ADDENDUM NO. 1

ISSUE DATE: **September 05, 2024**

RE: **CHAMBERLIN L&S SONGS PHYSICS LAB RENOVATION
UNIVERSITY OF WISCONSIN-MADISON
MADISON, WISCONSIN**

UW-Institution Project No. 0055-2346
UWSA Project No. A-23-012

1 DEMOLITION PLAN - LEVEL 04
Scale: 1/4" = 1'-0"

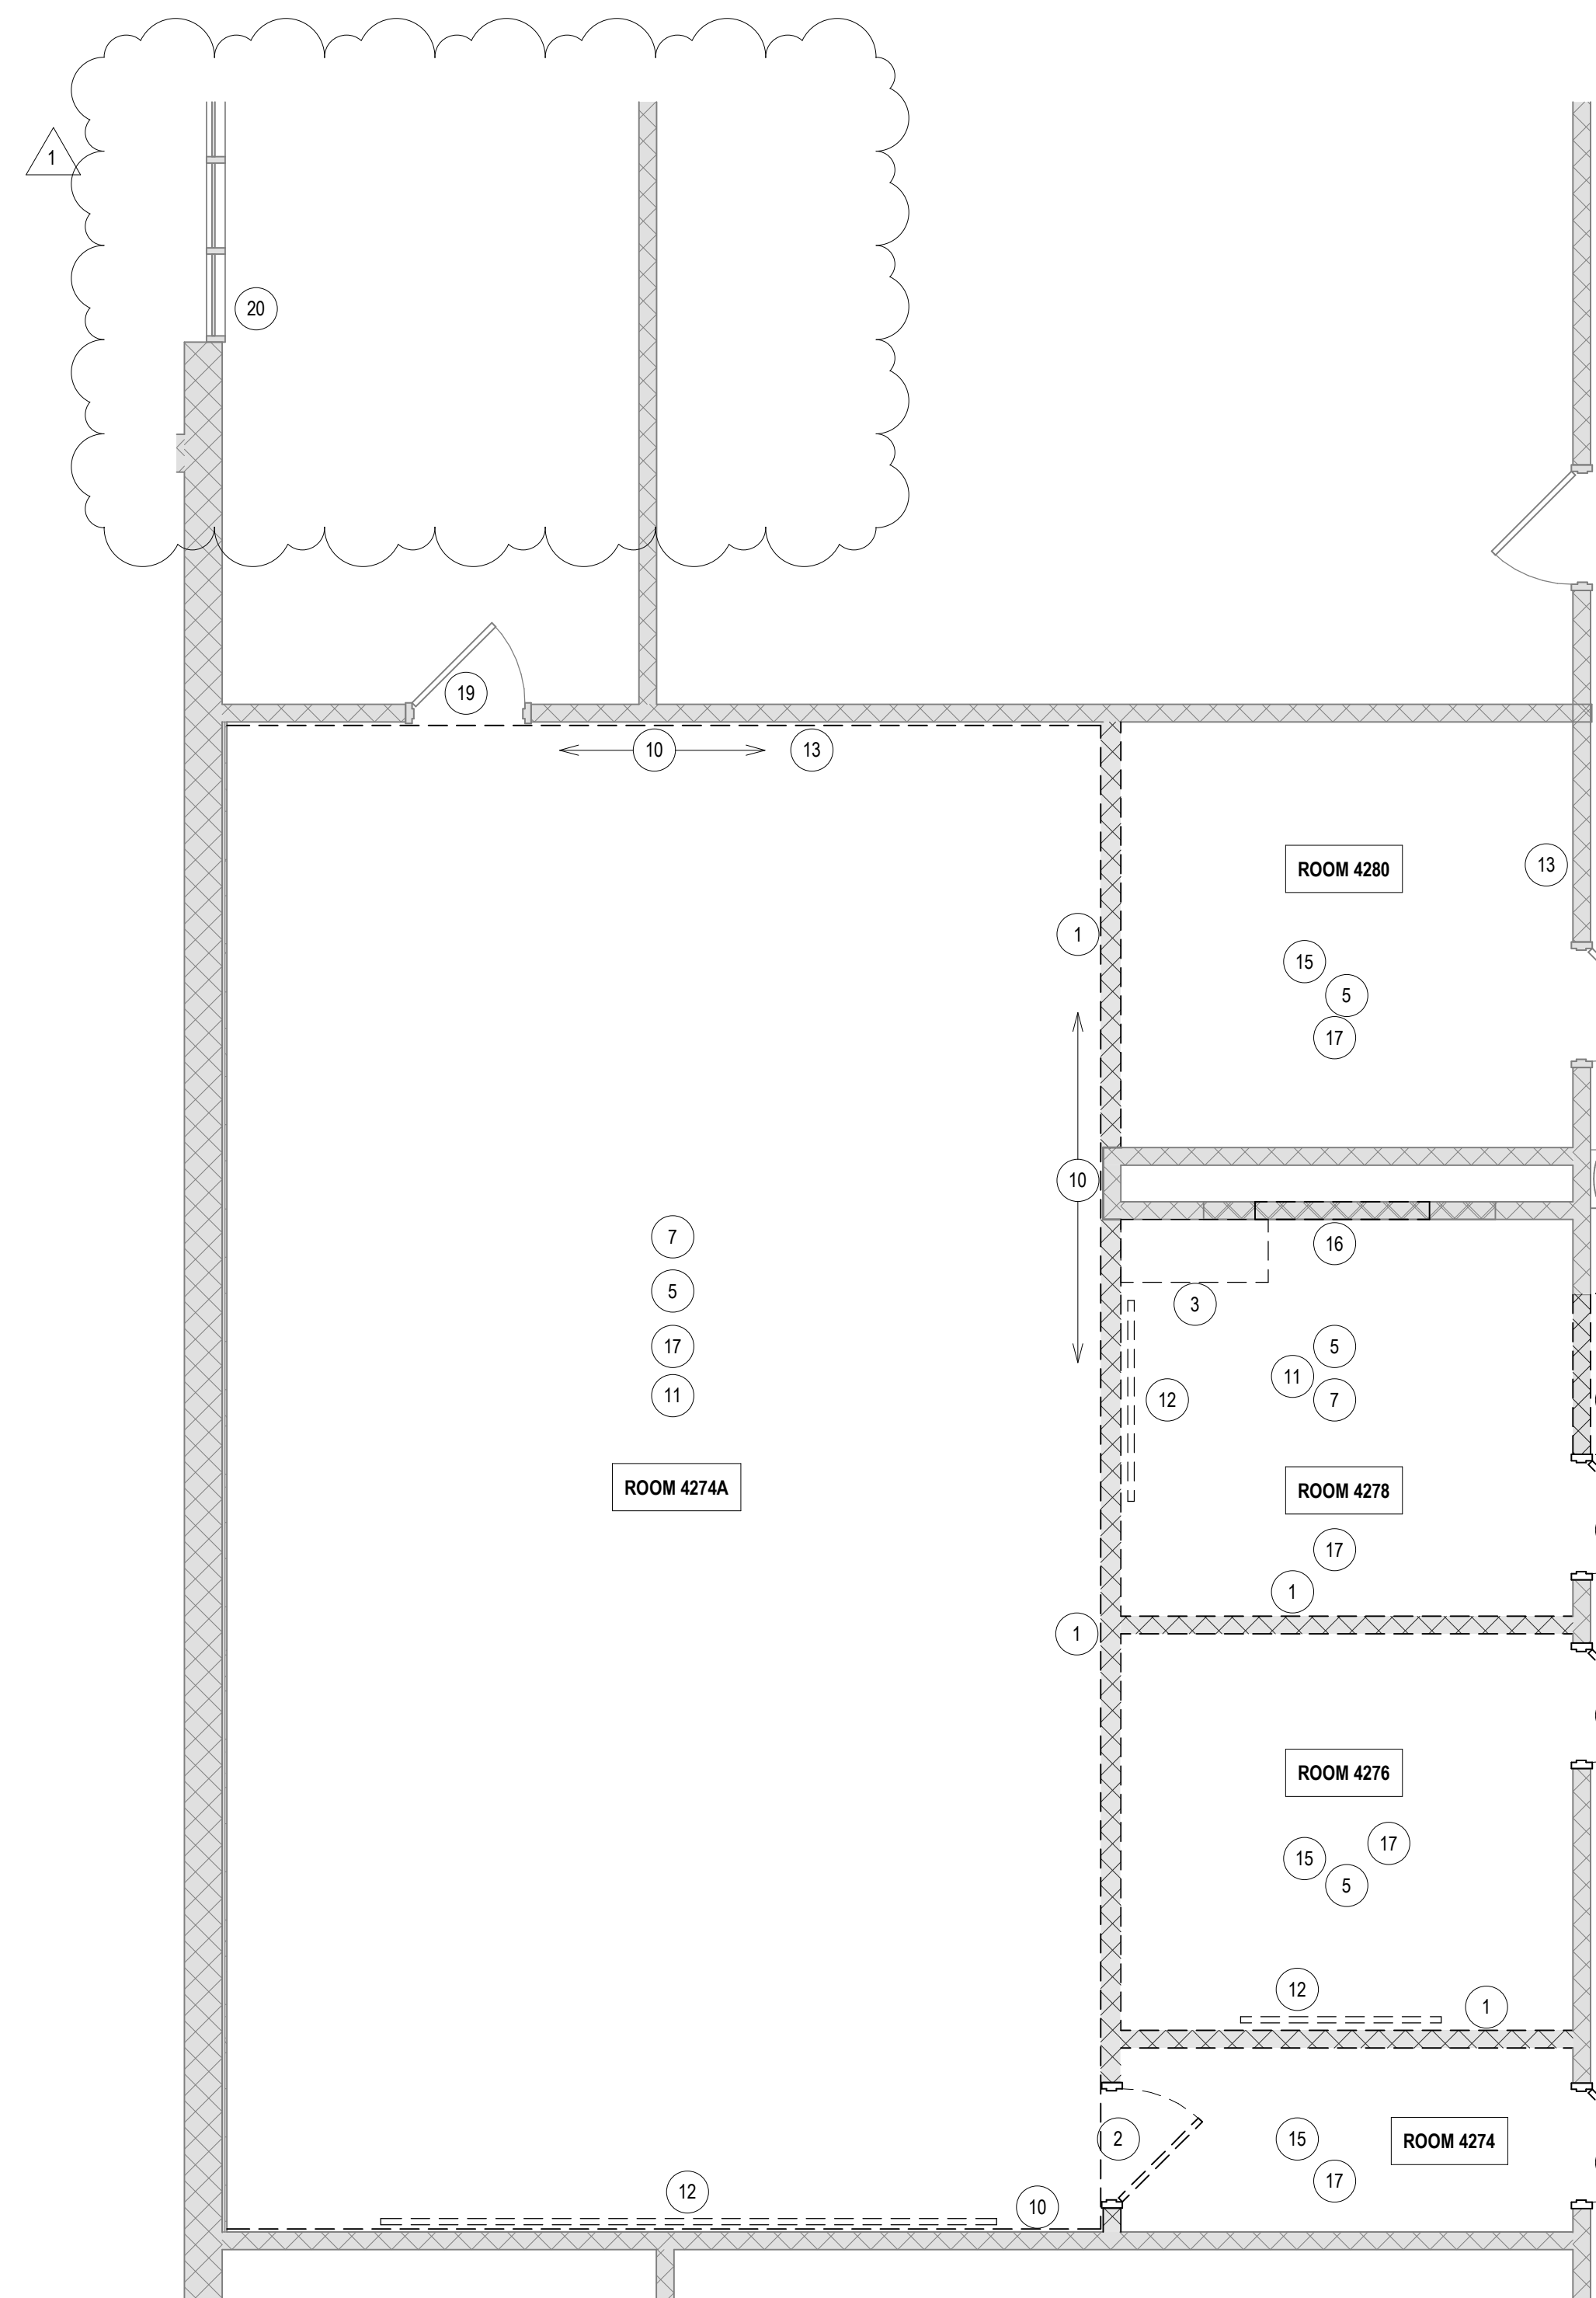
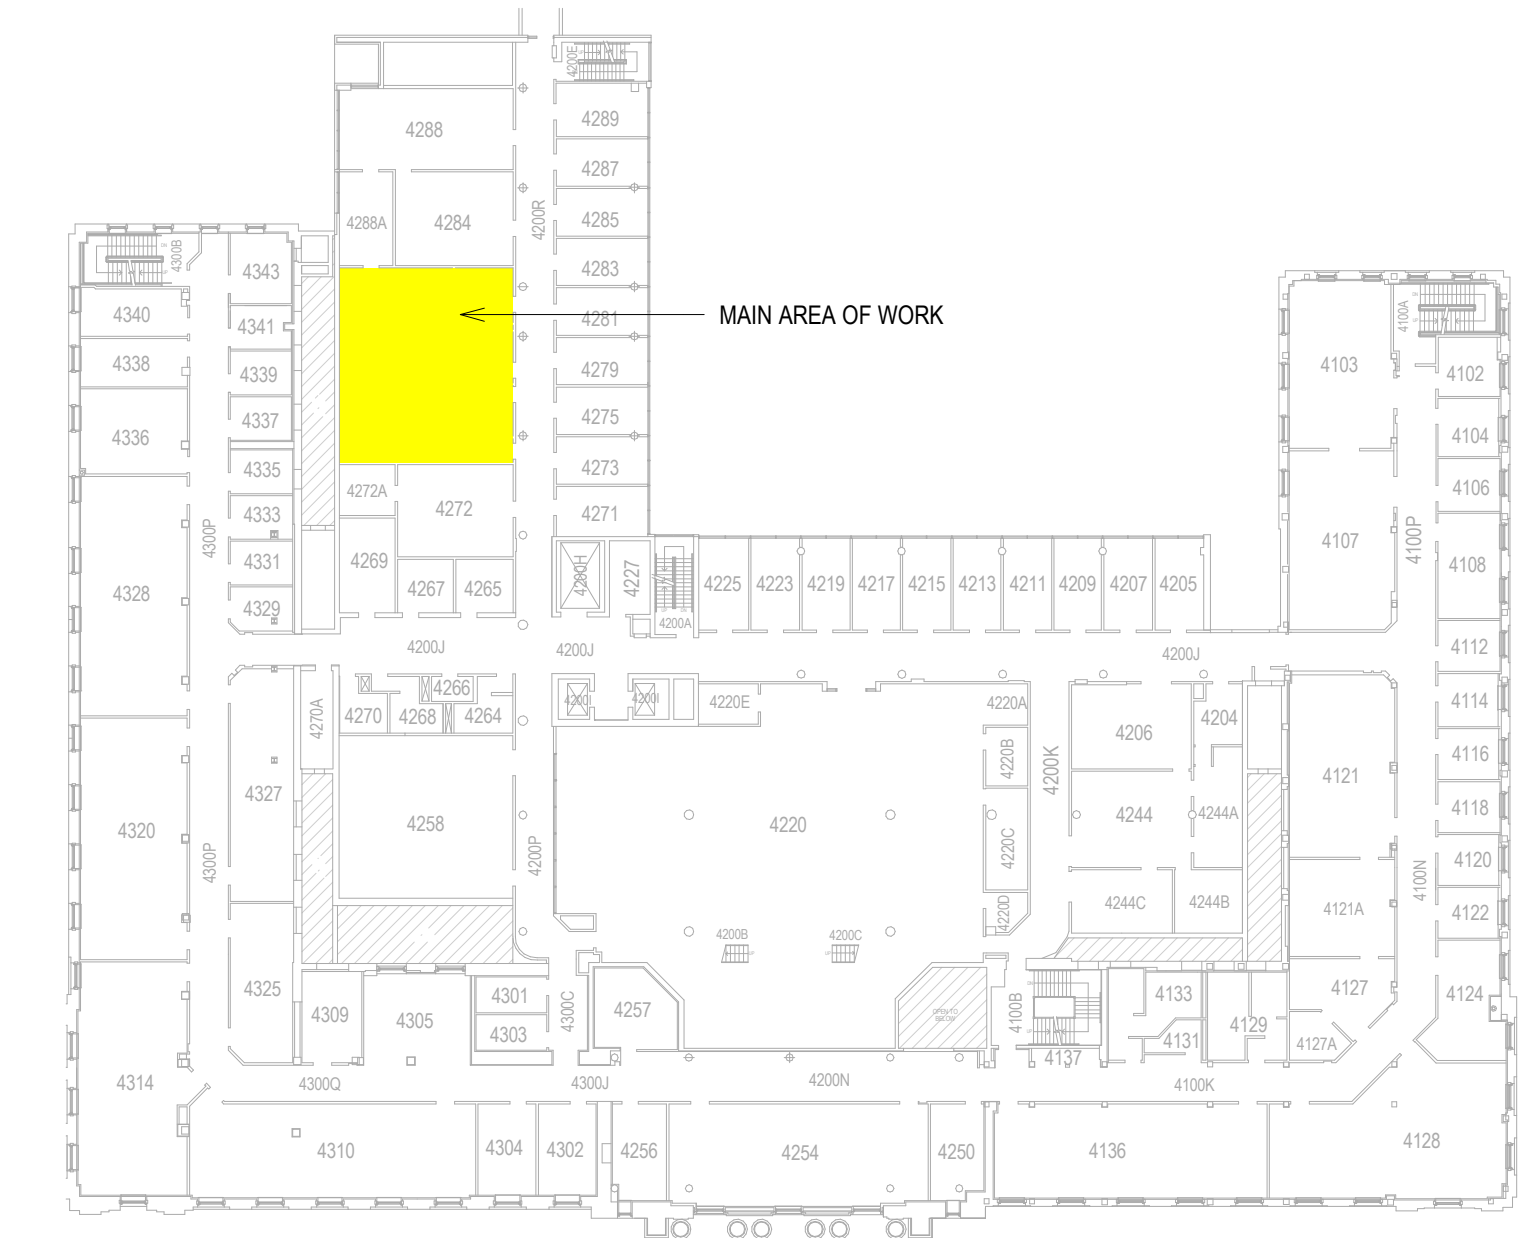
1. Sheet A101 – DEMOLITION PLAN – LEVEL 03
 - a. Add demolition plan keynote 20.
2. Sheet A102 – DEMOLITION PLAN – LEVEL 04
 - a. Add demolition plan keynote 20.
3. Sheet E201 – NEW WORK PLAN – LEVEL 03 - ELECTRICAL
 - a. Revise power general note to clarify the number of current carrying conductors allowed to be installed in a single conduit prior to conductor derating.
4. Sheet E211 – NEW WORK PLAN – LEVEL 04 - ELECTRICAL
 - a. Revise power general note to clarify the number of current carrying conductors allowed to be installed in a single conduit prior to conductor derating.
